PROPOSED EXTENSION FOR

B & J BERRY
DRAWN Alan A. D. GASSON

Marked up
J. Robinson
11/4/96

SUN DECK & FLOOR
FOUNDATION DETAILS

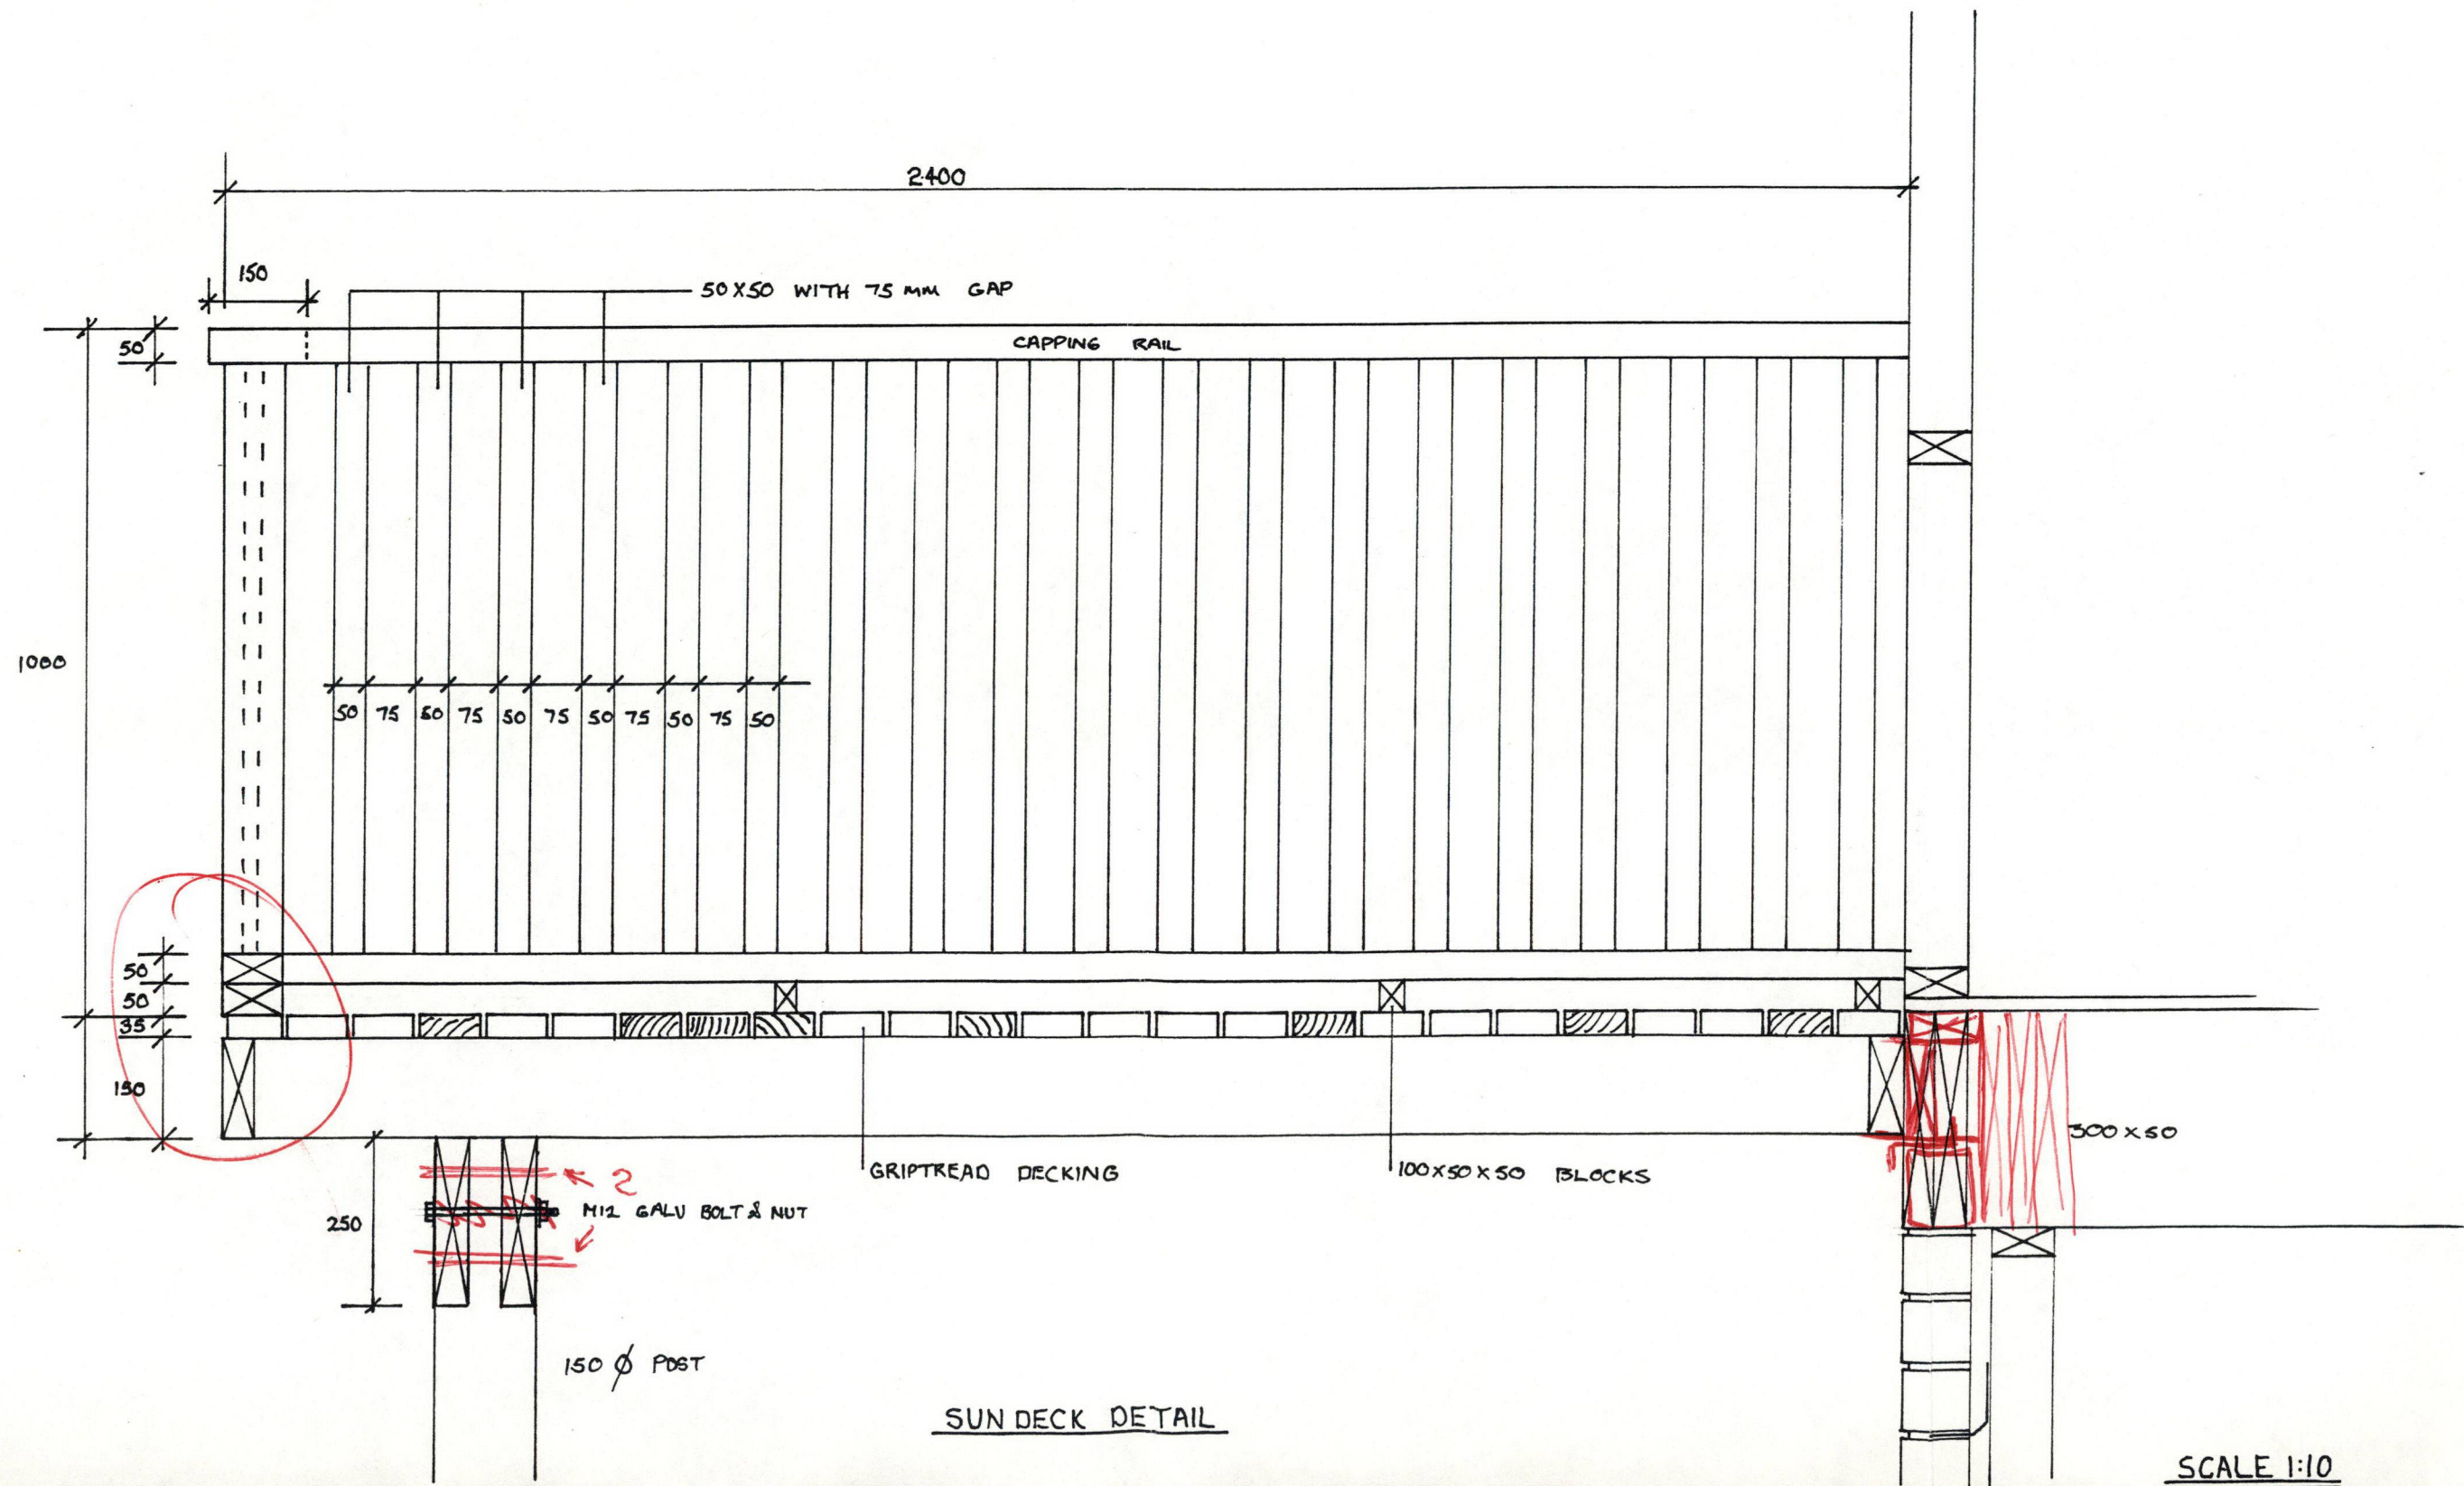
Wall insulation?

B1 paper?

Need better
fixings to
balusters.

Flashing

3-300x50 limel
(or 2-300x75)
(or 2-350x50)

Vapour barrier

Vapour barrier
under all of
floor & foundations
& behind wall

Bolts &
DPC?

Needs
gravel or
pea metal &
Topsoil
(200mm)
max.

50 cover
to vertical

BLOCKWALL DETAIL

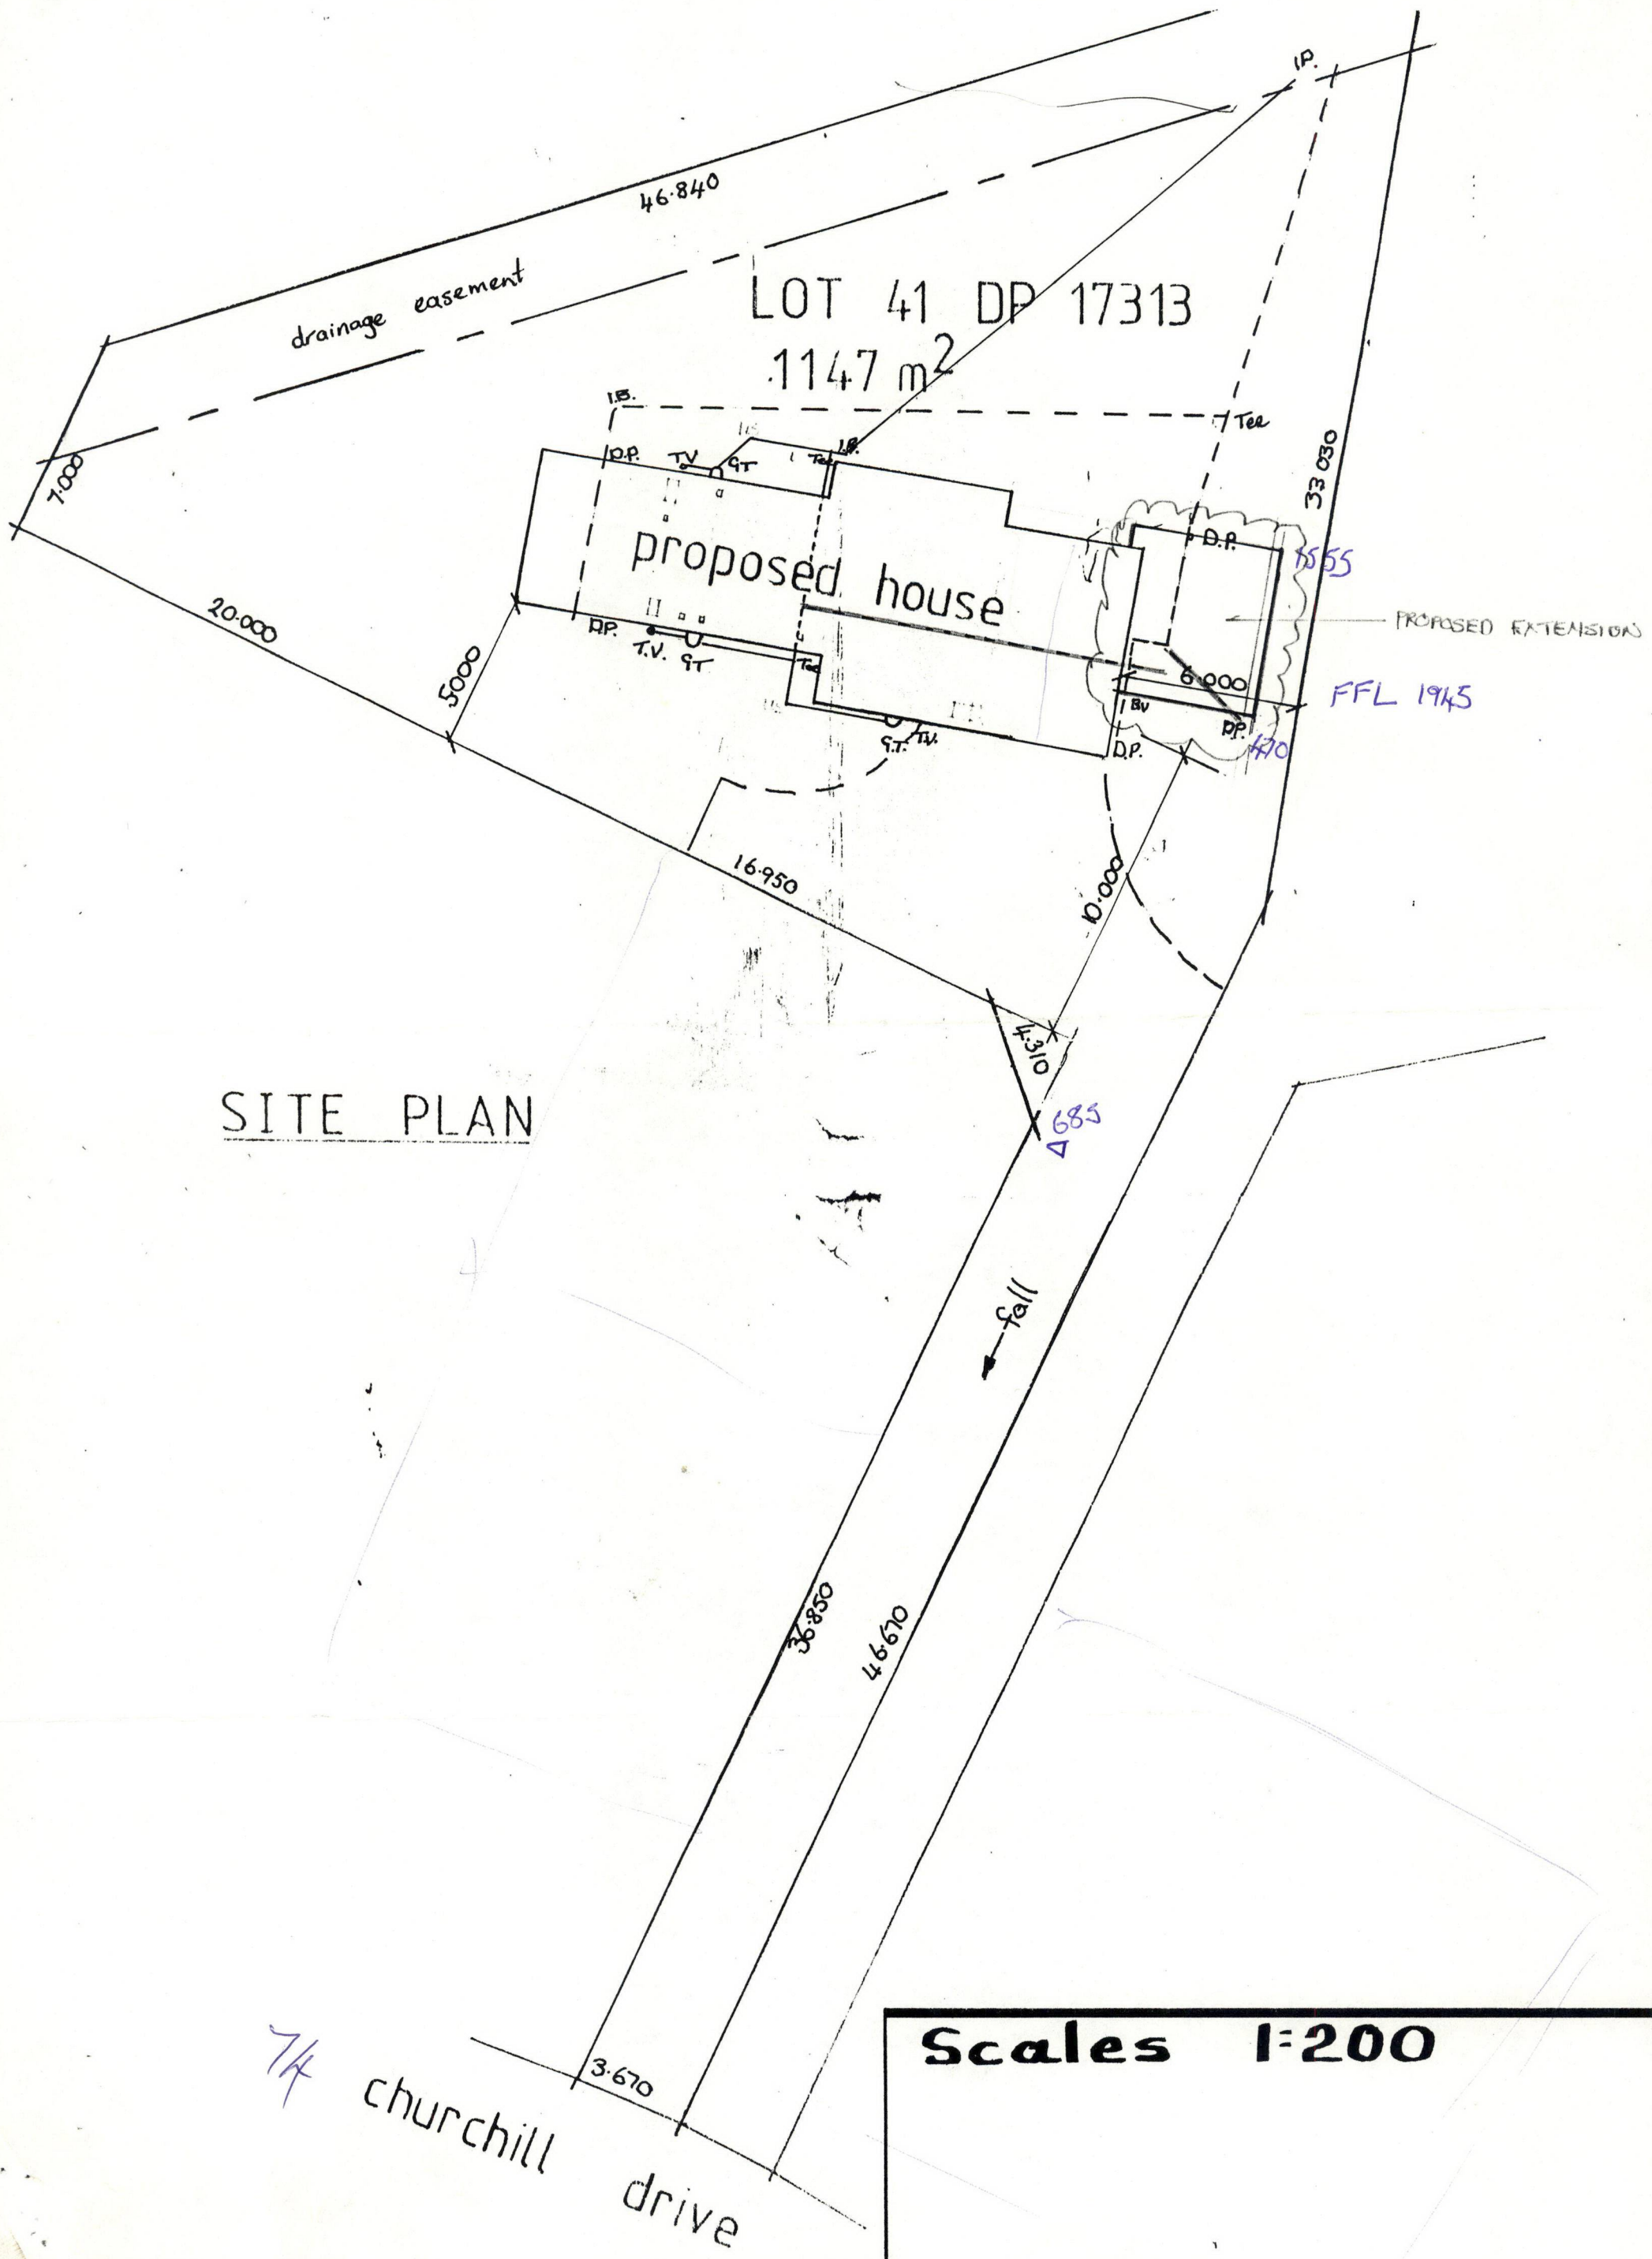
75 cover
DNO Novaflo to outfalls.
